V-Lock cord retaining feature as standard.

Product Change Notification					PCN GSP1 New with V-Lock Notch		
owner	creation date	release date	released by	change order no	rev	page	D10-032-636
hollenpe	10.12.2018	14.03.2019	limachcl	2014647	A	1 of 2

Old product appearance	New product appearance with V-Lock notch

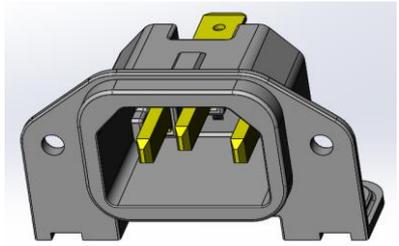
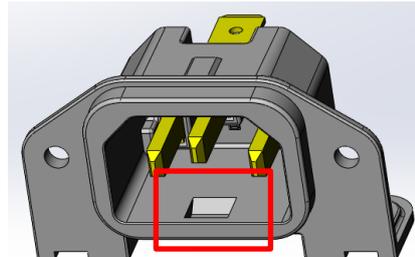
Tooling was updated to include the V-Lock cord retaining feature for all affected part numbers.

Change of the tooling to improve the quality of the optionally available V-Lock notch and to implement it as a standard feature for the product GSP1.

Form	Yes	New form is fully backwards compatible
Fit	No	-
Function	Yes	V-Lock feature is standard (not an option anymore)
Production Site	No	-
Product Label	No	-
Customer Action	No	-
